**SUBJECT: FINAL REPORT - ORISE SUPPORT OF NRC LICENSE INSPECTION AT
FORT ST. VRAIN ON SEPTEMBER 25 TO 27, 1995 (DOCKET NO. 50-267,
RFTA #95-30)**

**CONFIRMATORY SURVEY ACTIVITIES
FOR THE
FORT ST. VRAIN NUCLEAR STATION
PUBLIC SERVICE COMPANY OF COLORADO
PLATTEVILLE, COLORADO**

FIGURE 1: Fort St. Vrain Facility, Electrical Warehouse #14 - Measurement and Sampling Locations

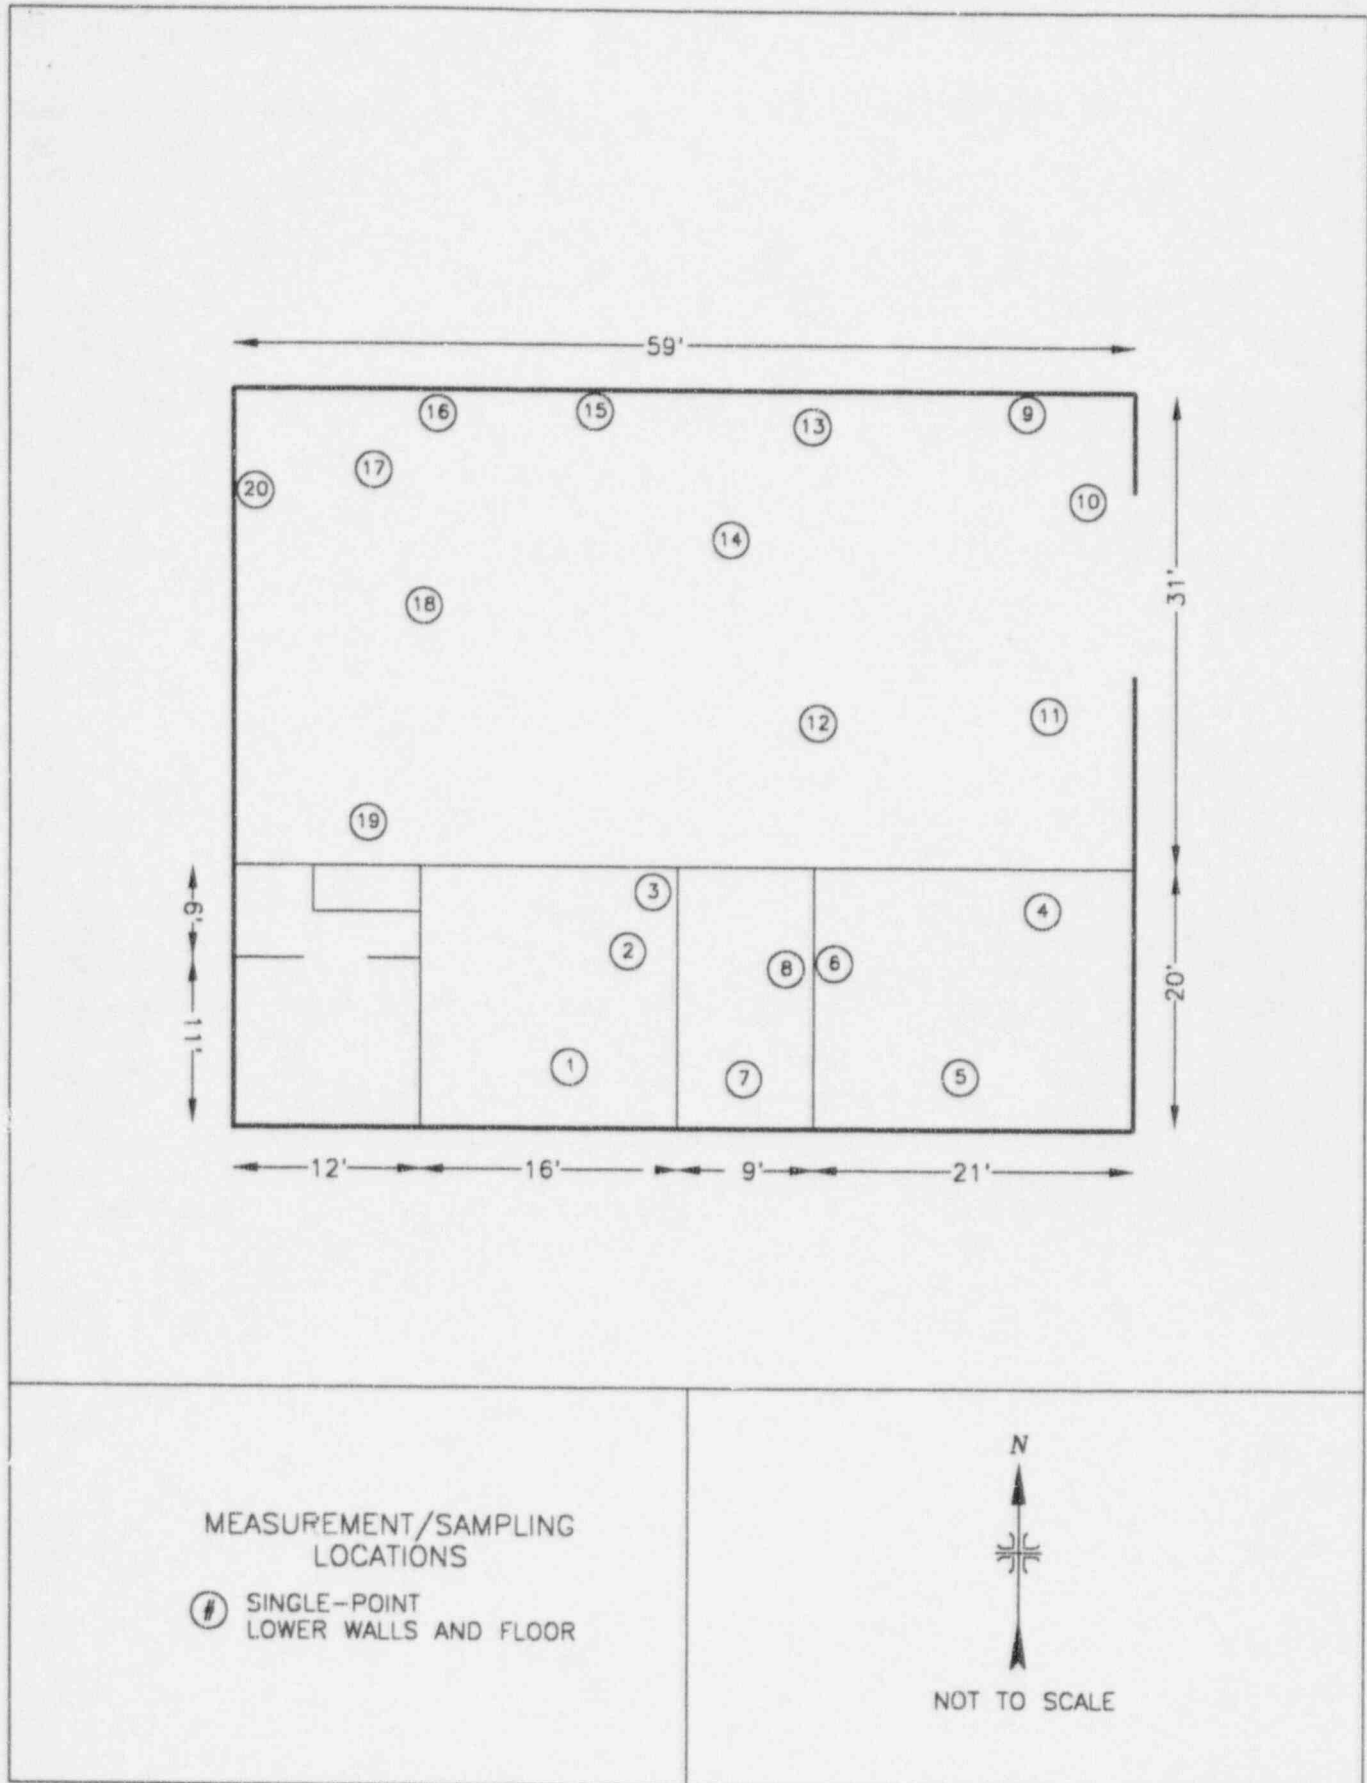
- survey area was classified as unaffected, although radioactive material was stored in the northeast area of the Electrical Warehouse.
- survey area was classified as unaffected, although numerous final survey surface activity measurements exceeded both the 25% of guideline action level and the guideline.
- all forms were not signed and dated.
- difficult to relate survey location code from instrument download sheets to survey map locations.

It should be noted that following our document review, the licensee stated that the survey packages being reviewed have not been completed by FSV—data reviews, investigations, and data conversions to guideline units remained to be performed. However, the concern remains that FSV classified the Electrical Warehouse as unaffected although documentation stated that Electrical Warehouse had a history of radioactive material storage, and according to their final survey plan, unaffected areas are not expected to contain residual radioactivity based on the site history.

Since FSV only provided local area background-corrected surface activity levels in the Electrical Warehouse—shielded surface activity measurements were not performed by FSV on the floor in Level 3 of the Reactor Building—data comparisons were not performed for the Reactor Building. Table 2 illustrates the surface activity comparison results for the Electrical Warehouse. Surface activity levels measured by ESSAP ranged from 103 to 569 dpm/100 cm², with an average of 301 dpm/100 cm² and standard deviation of 144 dpm/100 cm². FSV reported surface activity levels ranged from -267 to 560 dpm/100 cm², with an average of 199 dpm/100 cm² and standard deviation of 231 dpm/100 cm². A pairwise comparison *t*-test was performed to determine if the differences between ESSAP and FSV were statistically significant. Based on the pairwise comparison *t*-test, there are no statistically significant differences ($p > 0.05$) between FSV's and ESSAP's surface activity measurements in the Electrical Warehouse.

FIGURE 3: Fort St. Vrain Facility, Turbine Building, Level 5, Section C014 – Measurement and Sampling Locations

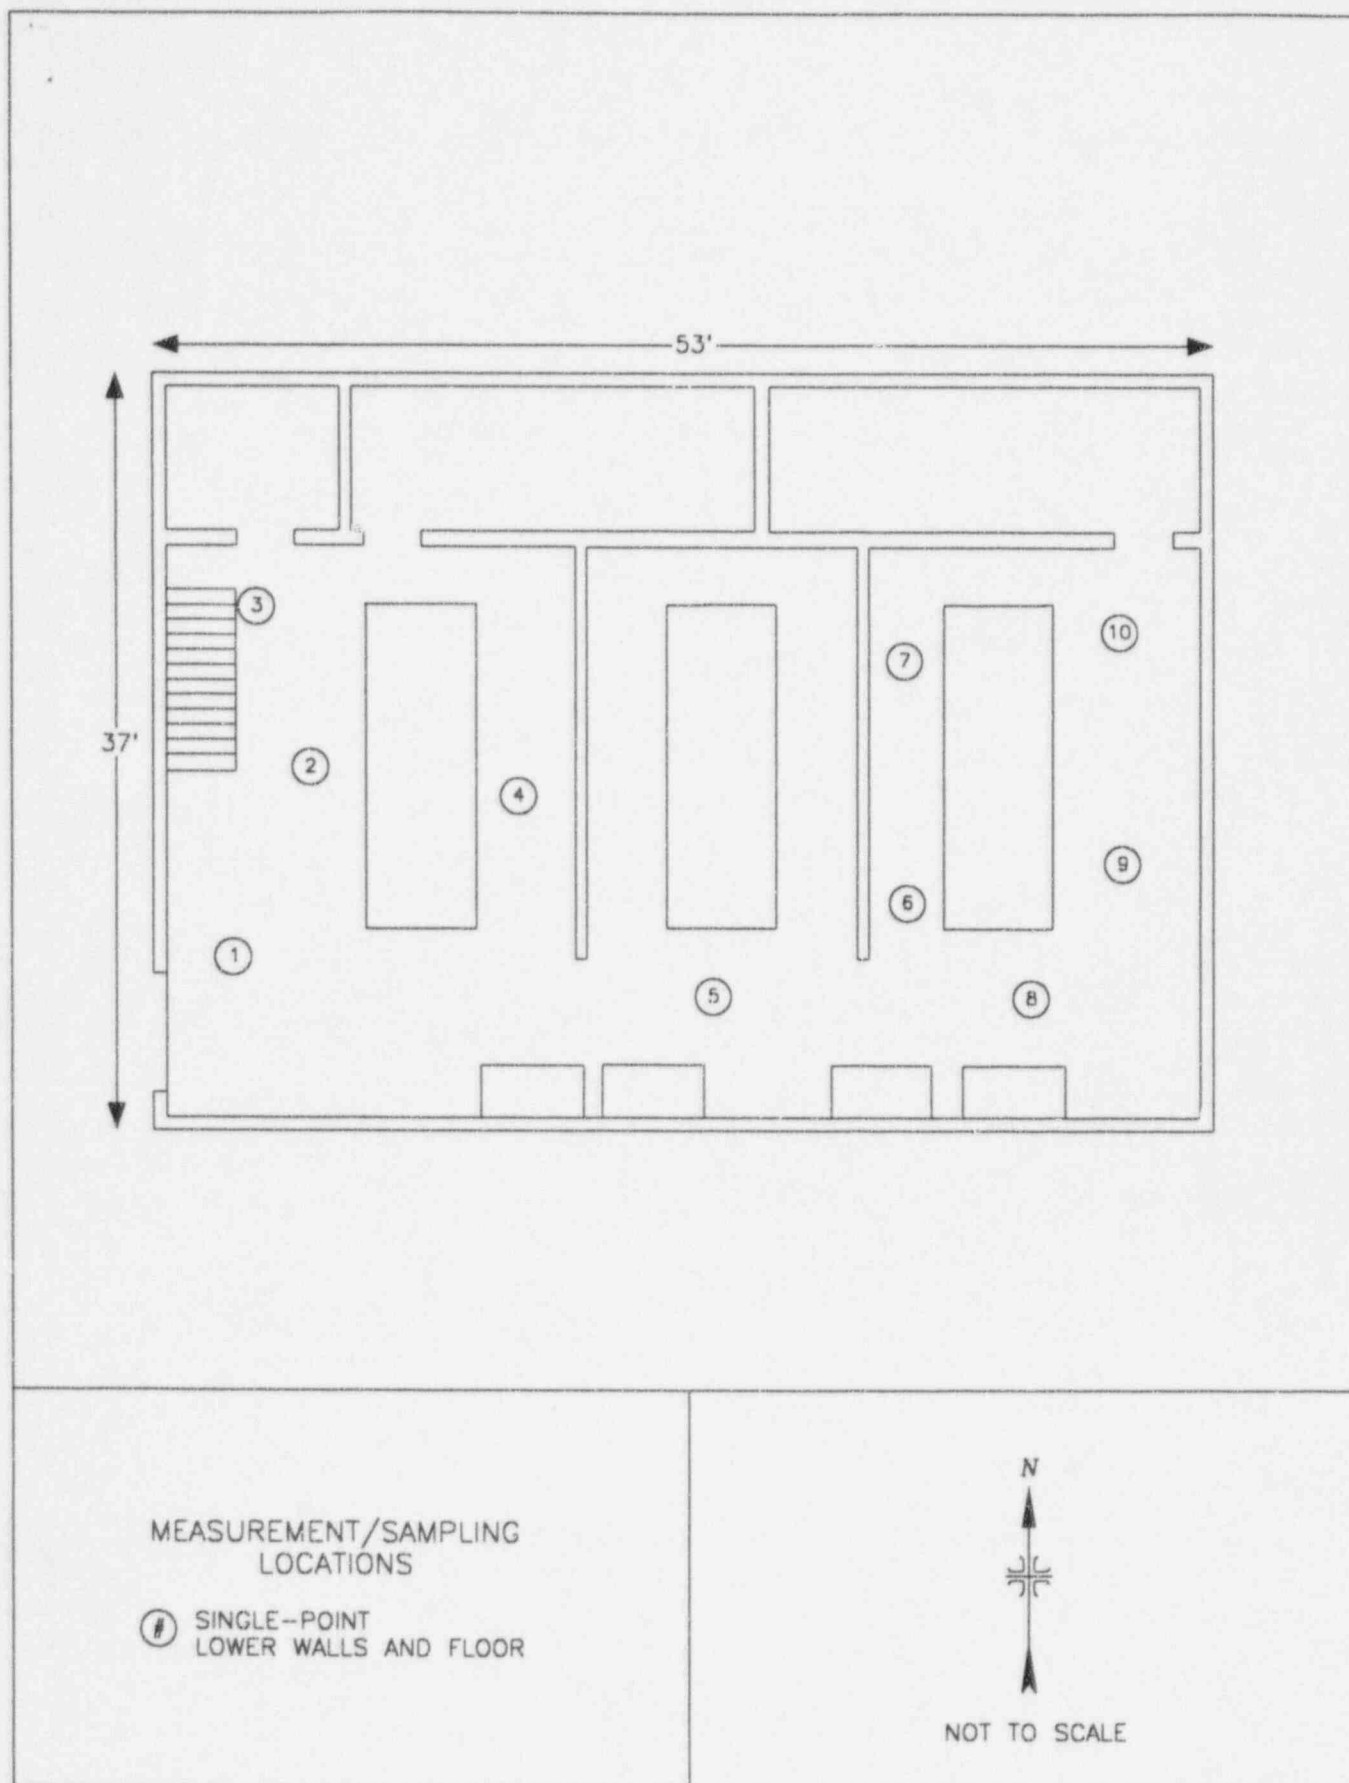
Field comparisons for background surface activity levels were performed in the Battery Room of the Turbine Building. Ten locations in the Battery Room were selected for background measurements. Table 1 illustrates the comparison of ESSAP and licensee detector response—in cpm per probe area—at each background location in the Battery Room. ESSAP performed 1 minute counts, while the licensee counted for 15 seconds at each location. The results indicate that the licensee's detector exhibits a substantially greater response—on the order of 30 to 40% higher—than ESSAP's gas proportional detector. Detector characteristics responsible for this difference may include voltage and threshold settings, dimensions of the corona wire, and grounding of the corona wire.

Comparisons of ESSAP and FSV gas proportional detector response in the Battery Room of the Turbine Building indicate that the licensee's detector exhibits a significantly greater response than ESSAP's gas proportional detector. Side-by-side surface activity measurements in the Electrical Warehouse indicate that there are no statistically significant differences between FSV's and ESSAP's surface activity measurements in unaffected areas that exhibit background or near background levels—i.e., where no licensed material is present.
